Entergy Operations, Inc.
1448 S.R. 333
Russellville, AR 72802
Tel 501 858 5000

OCAN080305

Subject: Arkansas Nuclear One - Units 1 and 2
Docket Nos. 50-313 and 50-368
License Nos. DPR-51 and NPF-6
Request for Additional Information Regarding the July 10, 2003, Fire
Protection Regulatory Conference

Responses to NRC Questions from July 10, 2003, Regulatory Conference

Figure 1: CFAST results for scenario 1a with open doors and mechanical ventilation

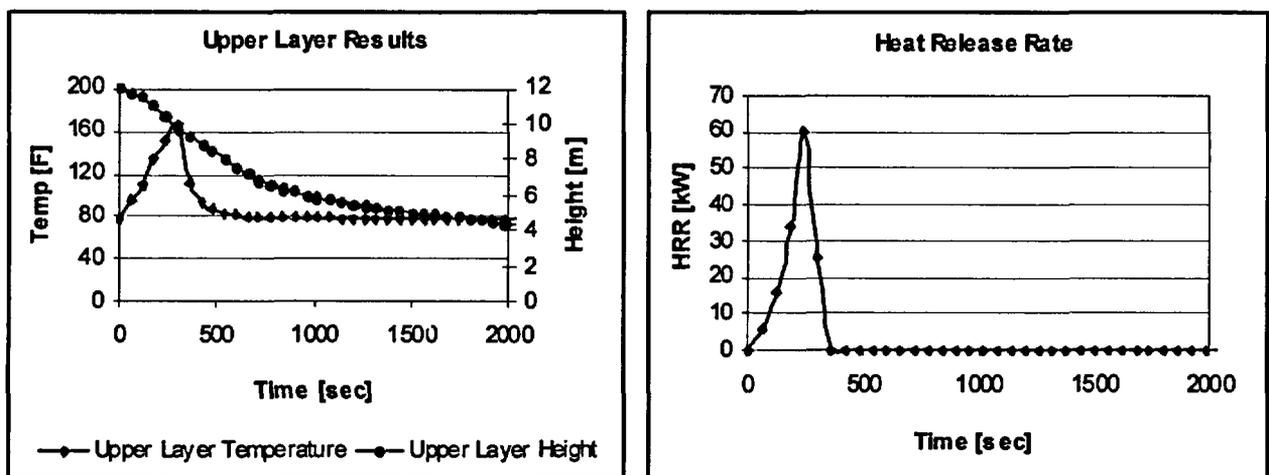
Please provide the CFAST model results for Fire Zone 99M, assuming forced ventilation is not secured and continues to supply air to the fire throughout the duration. In addition, please provide the input files you used in the CFAST fire simulation in all fire scenarios for Fire Zone 99M.

Figure 1 describes the results for Scenario 1a which consists of an elevated growing fire. The results indicate that if the door to zone 99-M is assumed open, the smoke layer will reach four feet high and temperatures in the room will reach a peak of 160° F. However, because the fire is immersed in smoke, the available oxygen in the room is consumed and the combustion process cannot be sustained. The temperature of the room is expected to return to ambient in around ten minutes. In this case, the ventilation system does not supply enough oxygen for supporting the fire. Furthermore, the injected air increases the size of the smoke layer, which completely covers the fire. This injected air also reduces the temperature of the hot gas layer.
